E/ECE/324 }
E/ECE/TRANS/505 } Rev.1/Add.94/Amend.3

Addendum 94: Regulation No. 95

Amendment 3

UNIFORM PROVISIONS CONCERNING THE APPROVAL OF VEHICLES WITH REGARD TO THE PROTECTION OF THE OCCUPANTS IN THE EVENT OF A LATERAL COLLISION

Figure 1

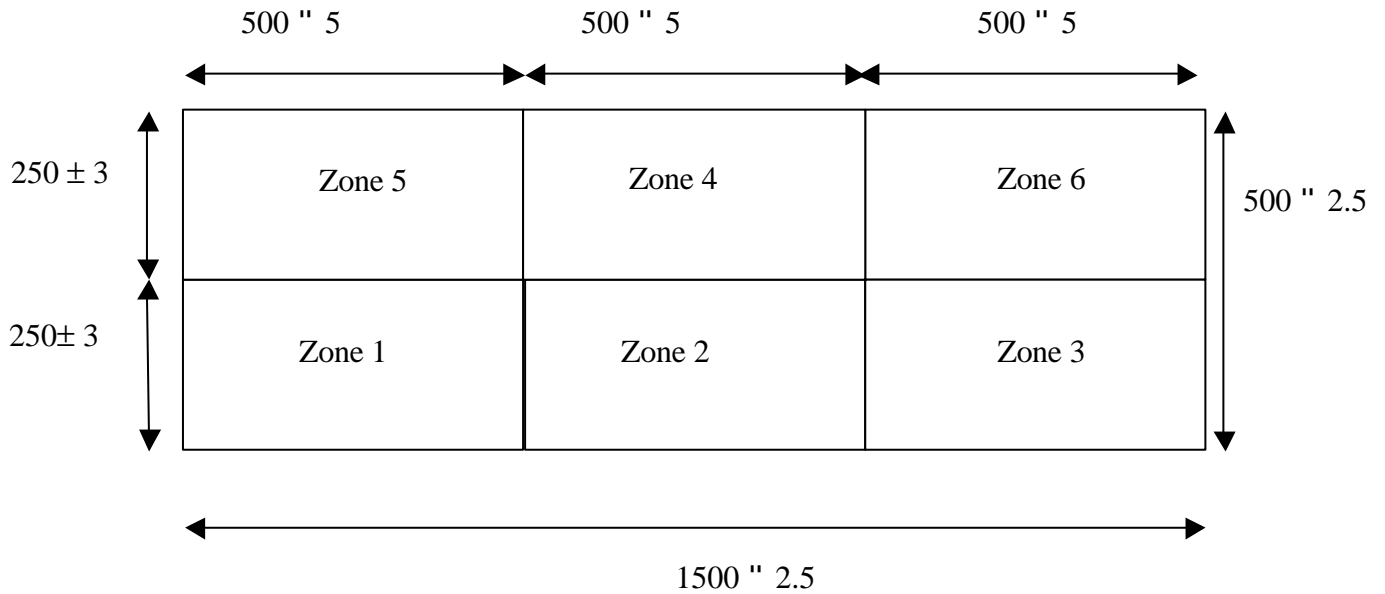
Annex 5, amend to read:

2.1.1.1. The impactor consists of 6 joined zones whose forms and positioning are shown in figures 1 and 2. The zones are defined as 500 ± 5 mm x 250 ± 3 mm in figures 1 and 2. The 500 mm should be in the W direction and the 250 mm in the L direction of the aluminium honeycomb construction (see figure 3).

2.1.1.3. The blocks must be centred on the six zones defined in figure 1 and each block (including incomplete cells) should cover completely the area defined for each zone).

Figure 2

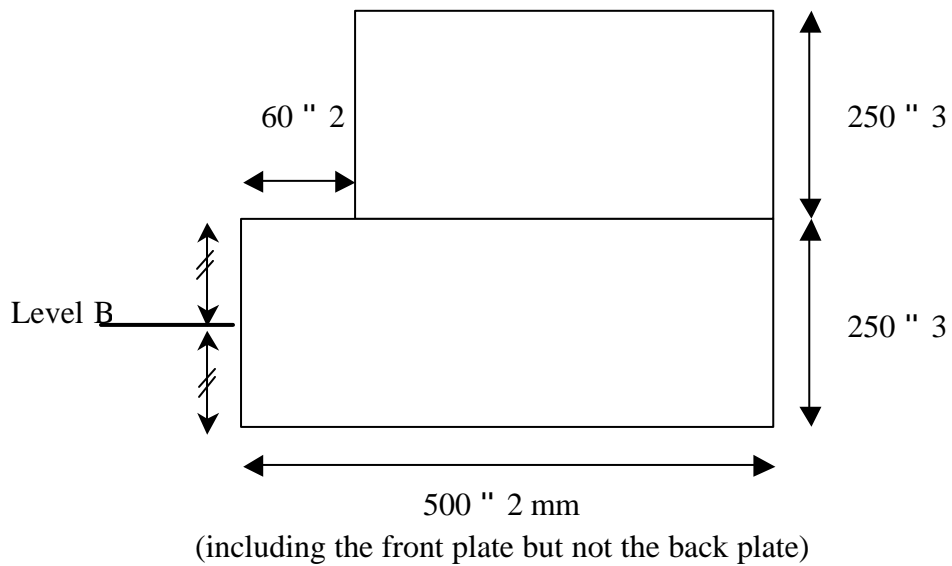
2.1.2.2. Blocks 1, 2 and 3 should be crushed by 10 ± 2 mm on the top surface prior to testing to give a depth of 500 ± 2 mm (figure 2).

- 2.1.5.15. The final residual static impactor deformation measured after the dynamic test at level B (figure 2) shall be equal to 310 ± 20 mm.
- 2.2. Front plates

- 2.2.1. Geometrical characteristics
- 2.2.1.1. The front plates are $1,500 \pm 1$ mm wide and 250 ± 1 mm high. The thickness is 0.5 ± 0.06 mm.
- 2.2.1.2. When assembled the overall dimensions of the impactor (defined in figure 2) shall be: $1,500 \pm 2.5$ mm wide and 500 ± 2.5 mm high.

Figure 4 - Dimension of Aluminium Honeycomb Cells

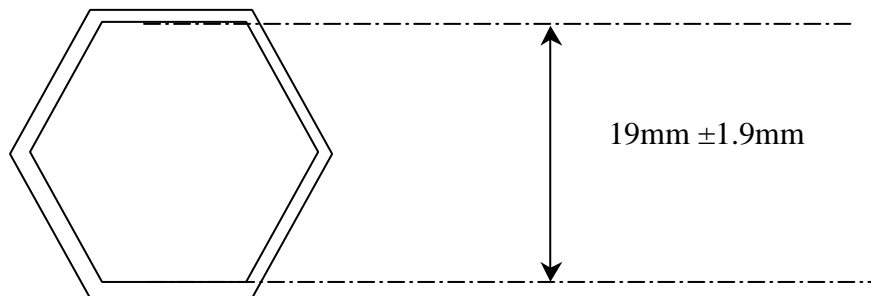
2.1.3.1. The cell dimensions shall be $19 \text{ mm} \pm 10$ per cent for each block (see figure 4).

Figure 5

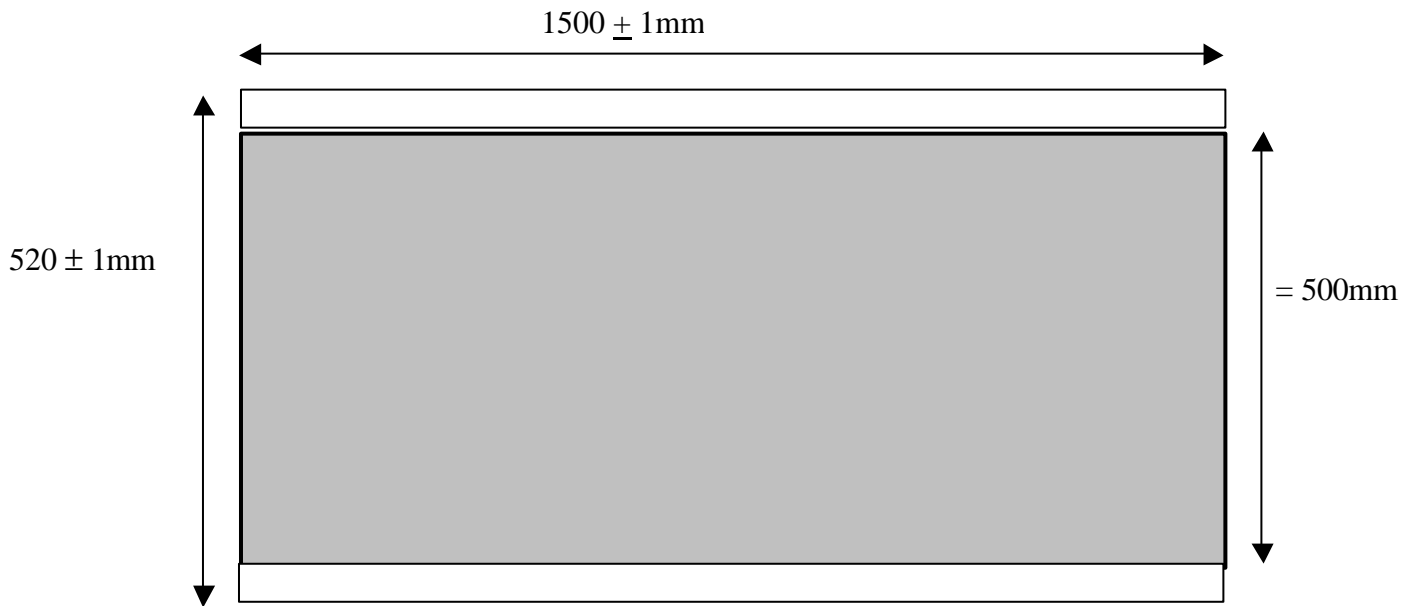
- 2.3.1. Geometric characteristics
- 2.3.1.1. The geometric characteristics shall be according to figures 5 and 6.
- 2.3.2. Material characteristics
- 2.3.2.1. The back plate shall consist of a 3 mm aluminium sheet. The back plate shall be manufactured from aluminium of series AlMg₂ to AlMg₃ with a hardness between 50 and 65 HBS. This plate shall be perforated with holes for ventilation: the location, the diameter and pitch are shown in figures 5 and 7.

- 2.4. Location of the honeycomb blocks
- 2.4.1. The honeycomb blocks shall be centred on the perforated zone of the back plate (figure 5).
- 2.5. Bonding

Figure 8

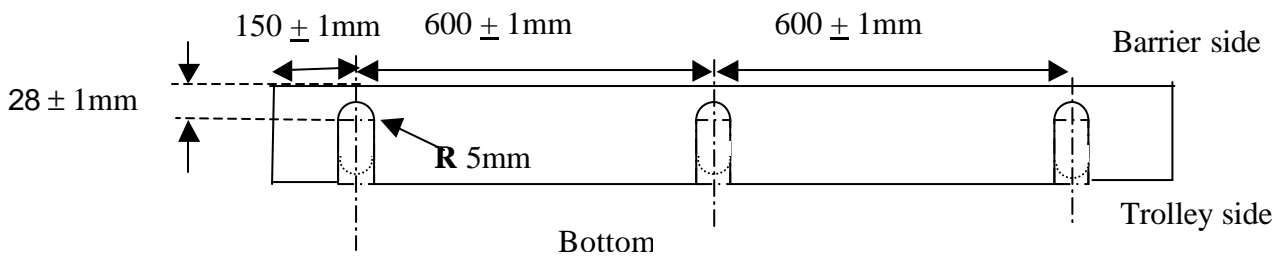
- 2.7.1. The fitting on the trolley must be according to figure 8. The fitting will use six M8 bolts, and nothing shall be larger than the dimensions of the barrier in front of the wheels of the trolley. Appropriate spacers must be used between the lower back plate flange and the trolley face to avoid bowing of the back plate when the attachment bolts are tightened.

VENTILATION FRAME

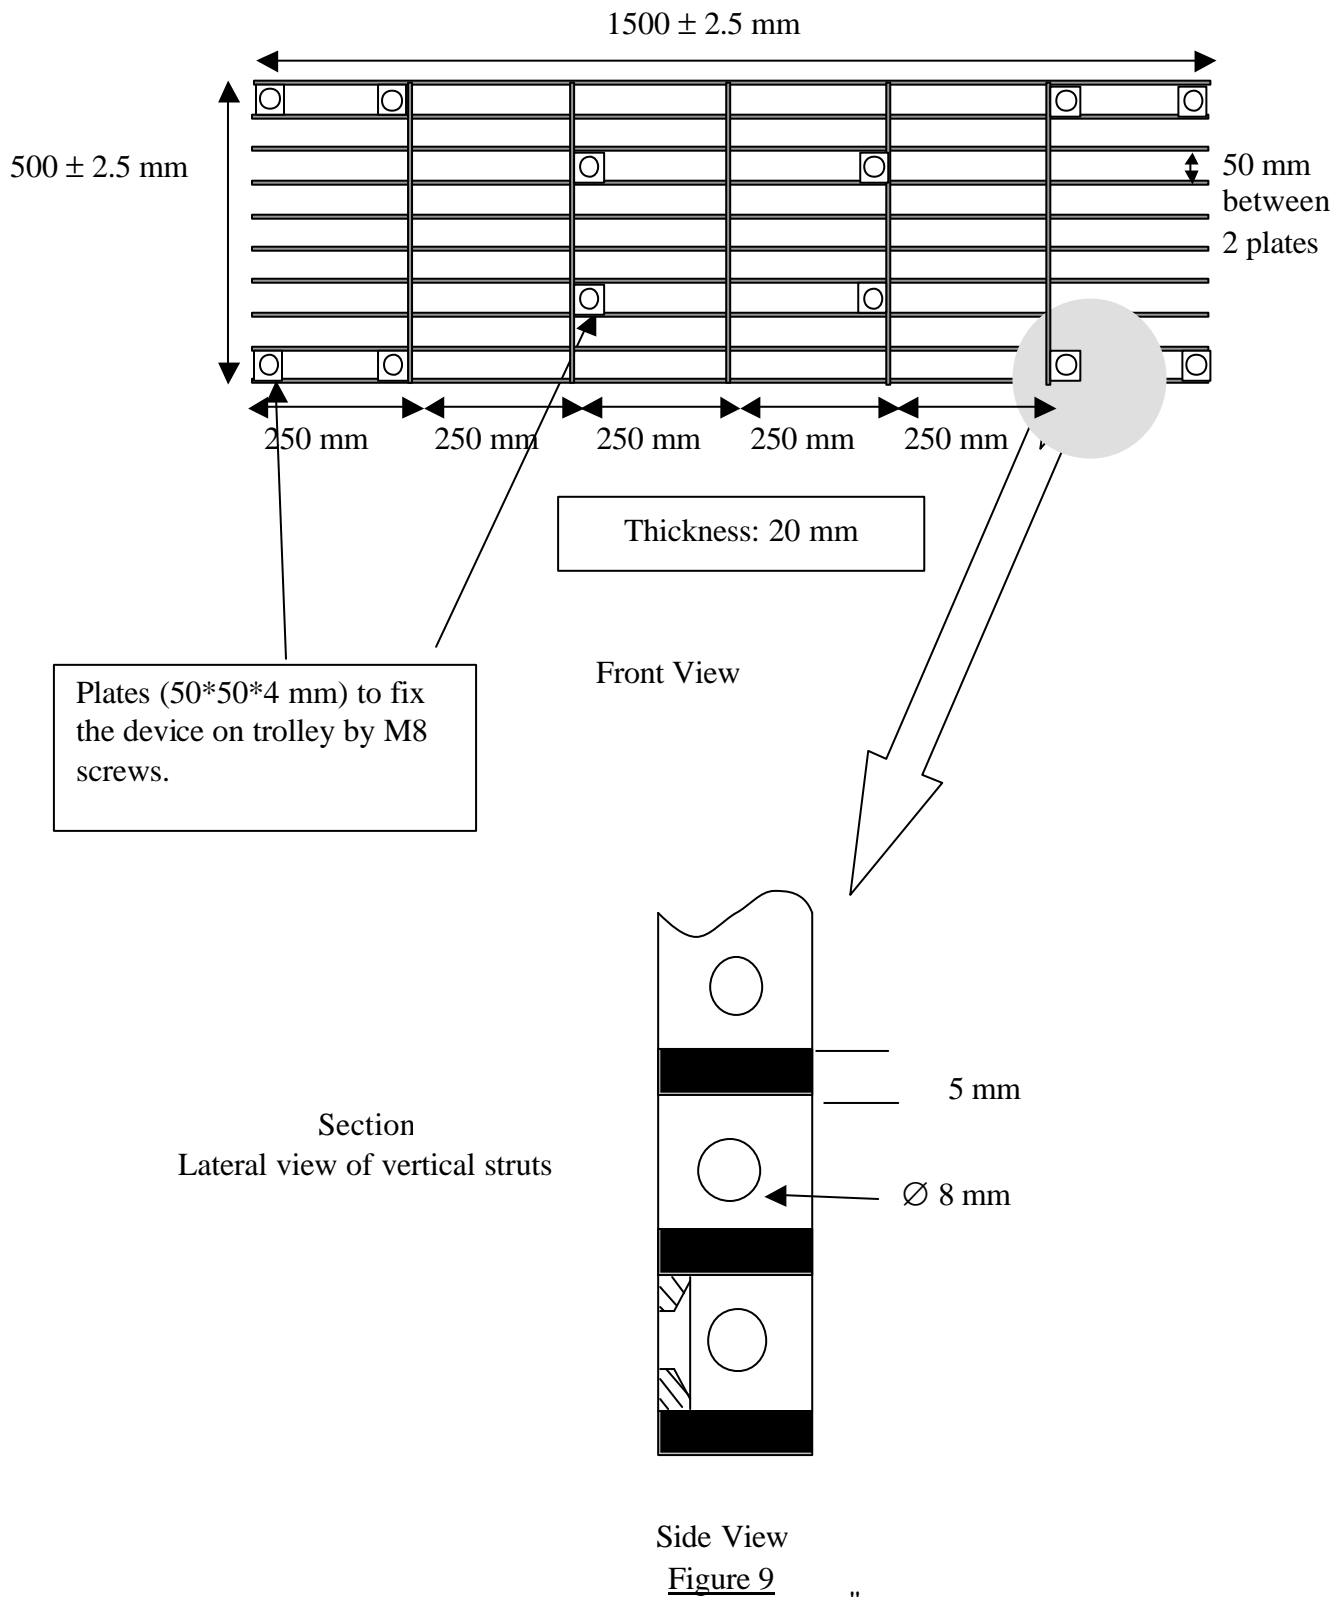
- 3.1. The interface between the trolley and the ventilation system should be solid, rigid and flat. The ventilation device is part of the trolley and not of the impactor as supplied by the manufacturer. Geometrical characteristics of the ventilation device shall be according to figure 9.

The ventilation device is a structure made of a plate that is 5 mm thick and 20 mm wide. Only the vertical plates are perforated with nine 8 mm holes in order to let air circulate horizontally.

Blocks 1 & 3
Figure 2a

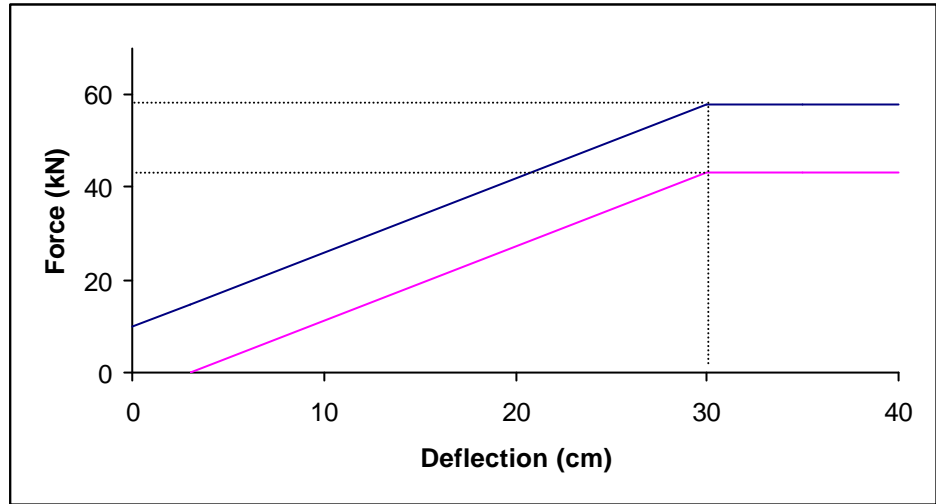
- 2.1.5.2.4. the sum of energy derived from deviating outside the corridor does not exceed 5 per cent of the gross energy for that block.
- 2.1.5.3. Blocks 1 and 3 are identical. Their rigidity is such that their force deflection curves fall between corridors of figure 2a.

Block 2
Figure 2b

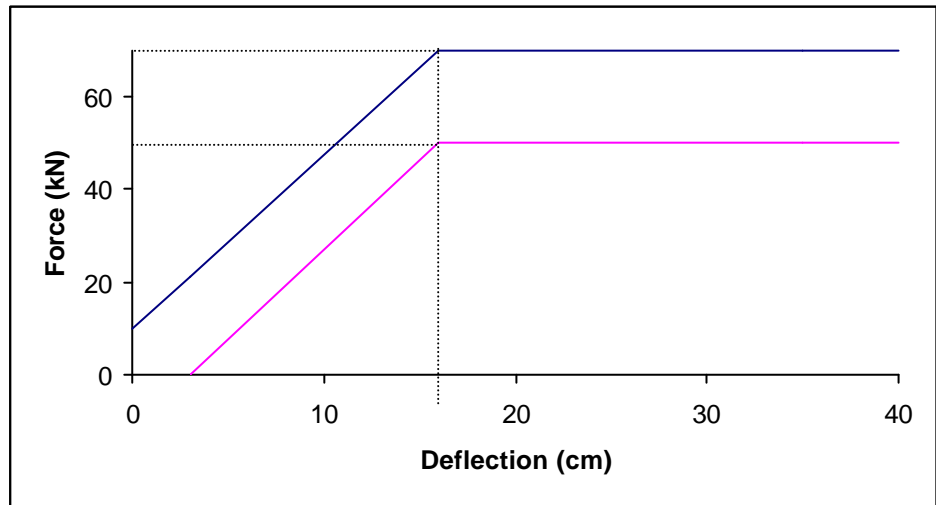
- 2.1.5.5 The rigidity of block 2 is such that its force deflection curves fall between corridors of figure 2b.
- 2.1.5.6. The rigidity of block 4 is such that its force deflection curves fall between corridors of figure 2c.

Blocks 5 & 6
Figure 2d

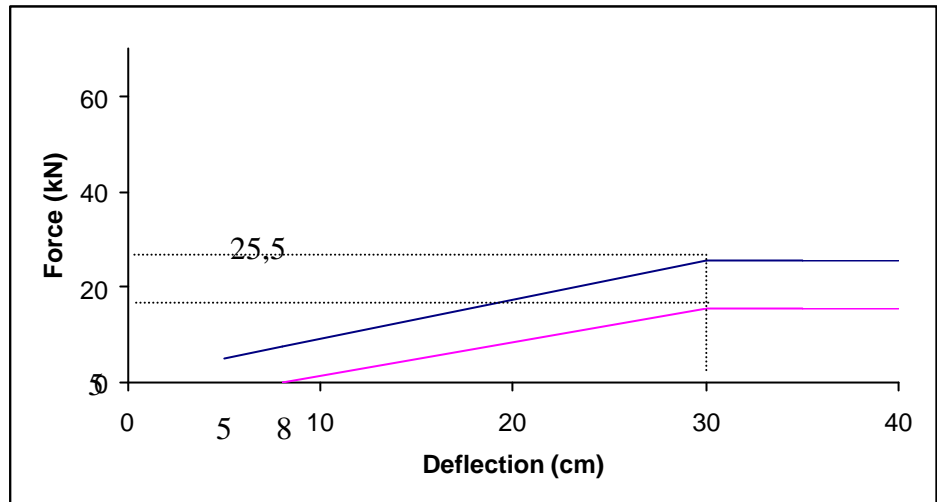
- 2.1.5.4. Blocks 5 and 6 are identical. Their rigidity is such that their force deflection curves fall between corridors of figure 2d.

Blocks total
Figure 2e

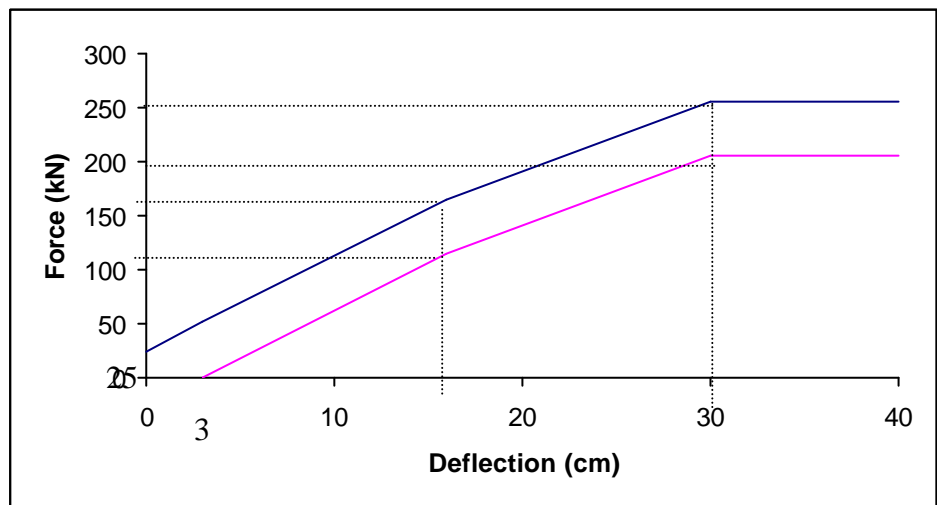
- 2.1.5.7. The force-deflection of the impactor as a whole shall fall between corridors of figure 2e.
- 2.1.5.8. The force-deflection curves shall be verified by a test detailed in annex 5, paragraph 6., consisting of an impact of the barrier against a dynamometric wall at 35 ± 0.5 km/h.
